RECALL CAMPAIGN

NHTSA #O7V-005/ T.C. #07-005

Job Code #9901072

Subject:	Hitch bolts loosening
Units Affected:	All Seneca and Greyhawk motorhomes built on Kodiak chassis
Action Required:	Remove original hitch hardware and replace with higher grade bolts.
Job Operation Code:	9901072
Series Code:	N/A
Flat Rate Time:	1.0 hrs.
Kit Part Number:	0700052
Tools Required:	1/2" drive 3/4" socket, ratchet, 1/2" drive extension, 1/2" drive 7/8" socket, 7/8" wrench, and 1/2" drive torque wrench (up to 200 ft/lbs min)
Additional Requirements:	N/A

Fig. 1

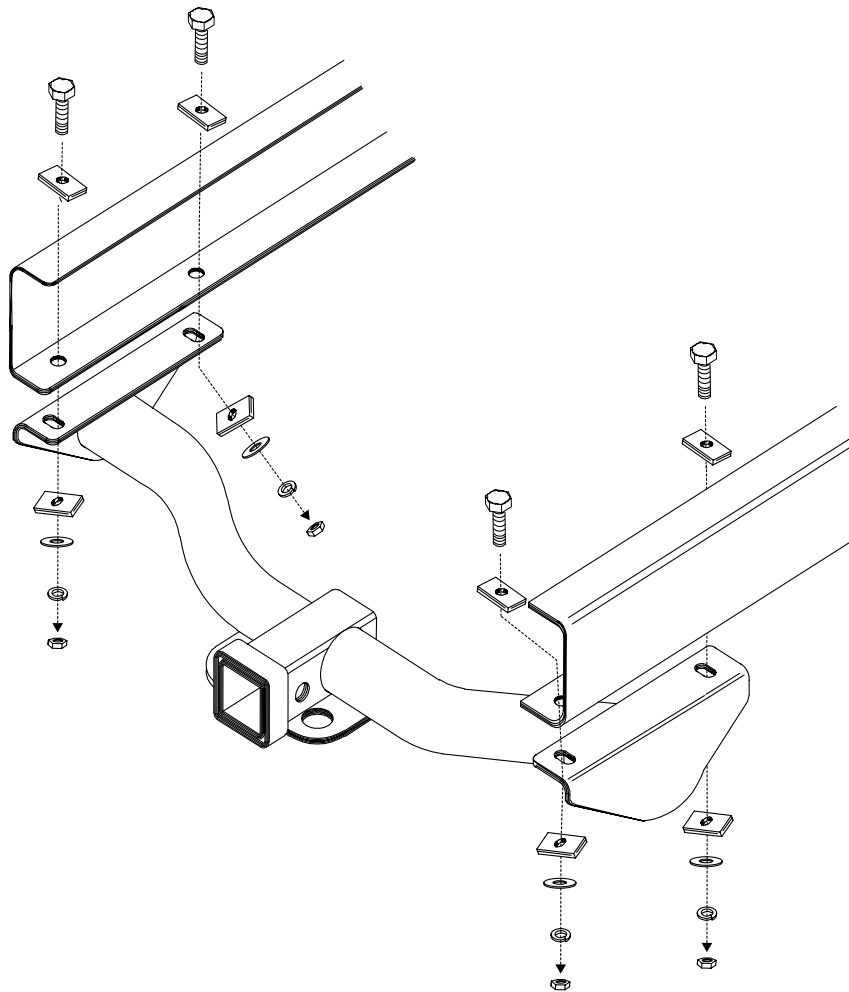
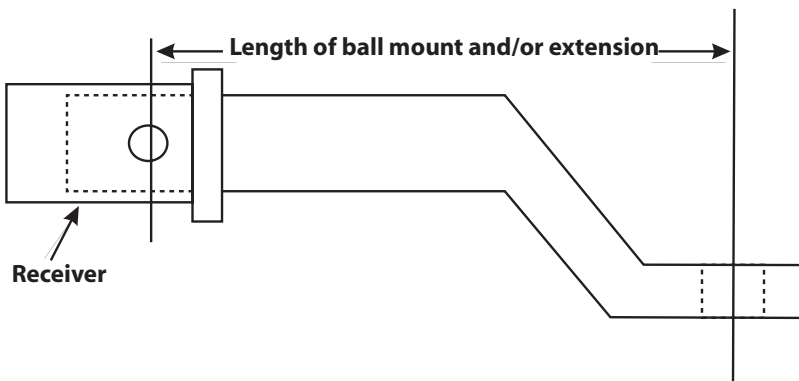
1. Remove one of the 1/2" carriage bolts from the hitch.
2. Insert a new 14MM bolt from the hardware kit into a new metal plate.
3. Insert the new 14MM bolt/plate down through the frame rail.

N NOTE: Some holes may need to be enlarged to accommodate the 14MM bolt.

4. Place a new plate, flat washer, lock washer and nut on the bottom side of the hitch. Hand tighten.
5. Repeat steps 1-4 for the other three-(3) bolts.
6. Torque all new hardware to 130 – 150 ft/lbs
7. Discard all original hardware.
8. Affix the decal supplied on the back bumper right next to the existing towing decal.
9. Educate customer on information listed on the customer sign off form.
